Final Third-Party Review of
Entergy Nuclear Vermont Yankee's Hydrothermal Modeling Report and 316(a) Demonstration
in Support of a Request for Increased Discharge Temperature Limits at Vermont Yankee Nuclear
Power Station During May through October

Prepared for:
Vermont Agency for Natural Resources,
Department of Environmental Conservation

Prepared by:
William Richkus and Stephen Schreiner
Versar, Inc.
9200 Rumsey Road
Columbia, MD 21045

May 9, 2003

FIGURE B.8

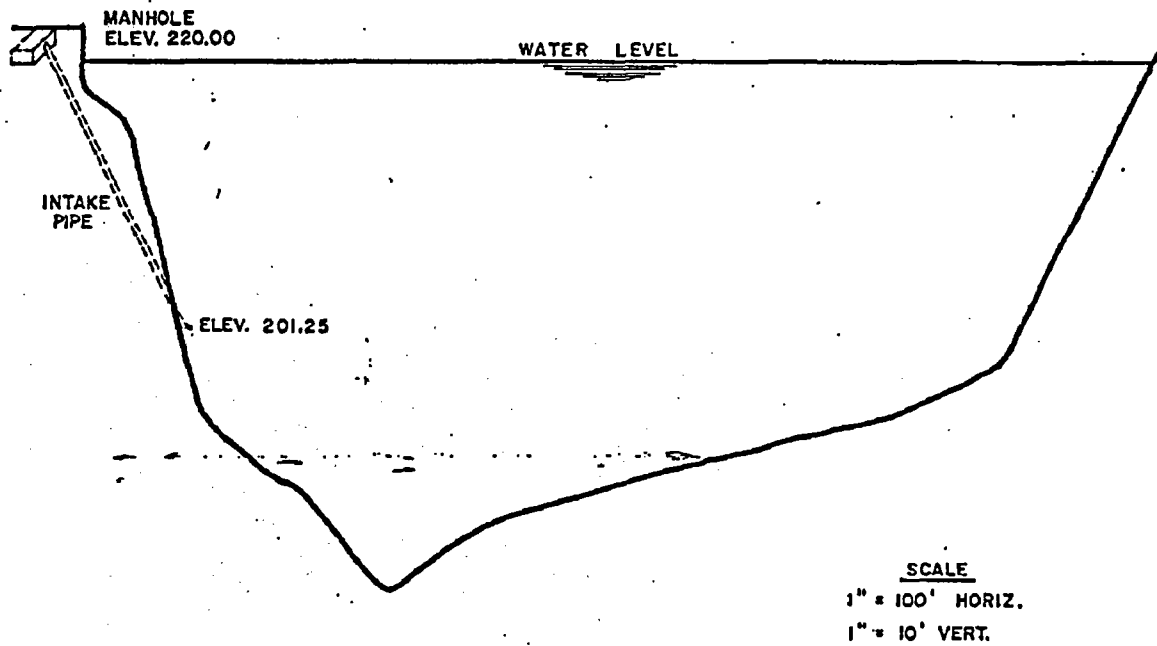
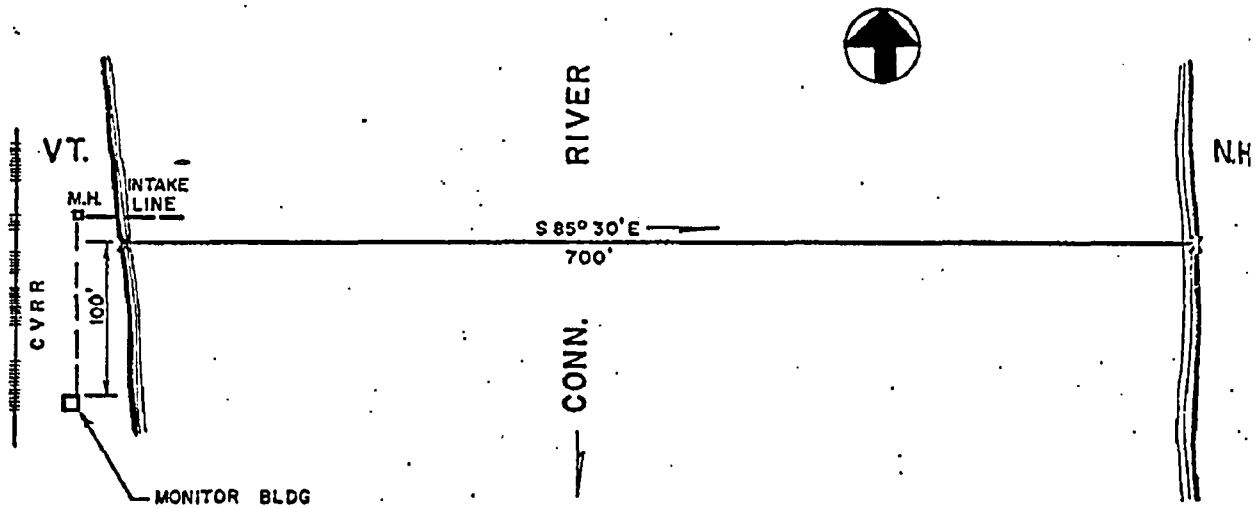
Based on ENVY's response to draft comments of April 29, our understanding of the Station 7 input data has been clarified. Station 7 is about 23 km downstream of Bellows Falls dam and is about 18 feet deep (diagrams of sampling locations at stations 3 and 7 are included in Appendix B). Temperature values at this location are used as the upstream boundary condition just below the dam, even though there may be thermal stratification in the pool at Station 7. This is acceptable since the Station 7 sample location is near the bottom and much less affected by thermal processes occurring in the pool near the water surface. A uniform temperature is used as an upstream boundary condition under the assumption of complete mixing just below the Bellows Falls dam. Natural thermal heating and cooling processes in the Vernon pool are then simulated in the model from that point downstream. Since the simulated and measured Station 7 data are very similar and since there is very little diurnal temperature change, this shows that little change in temperature occurs deeper in the water column and the assumptions listed above are reasonable.

- Section 3.1.4 - Station 7 information: a statement is made here that there can be as much as a 5F difference between surface and bottom at this station and that the assumption of a single ambient temperature is not always appropriate. Yet this data is used as an upstream boundary condition for the detail hydrothermal model as well as for the calculation of delta-T to the downstream station 3. The consequences of this assumption could be important and further consideration of this issue is warranted.

The Station 7 temperature was used as the upstream boundary temperature at Bellows Falls Dam. This decision was made because there appeared to be minimal longitudinal temperature variation in the upper pool away from any thermal effects from the discharge. The correctness of this decision is shown graphically in Figure 4-10 on page 41 of the ASA Hydrothermal Modeling report. The upper panel of the figure shows the model predictions compared to observations at Station 7 and clearly indicates that the model reproduces the correct temperature response even though the atmospheric heat transfer was occurring in the surface layers along the length of the river downstream from the Bellows Falls Dam.
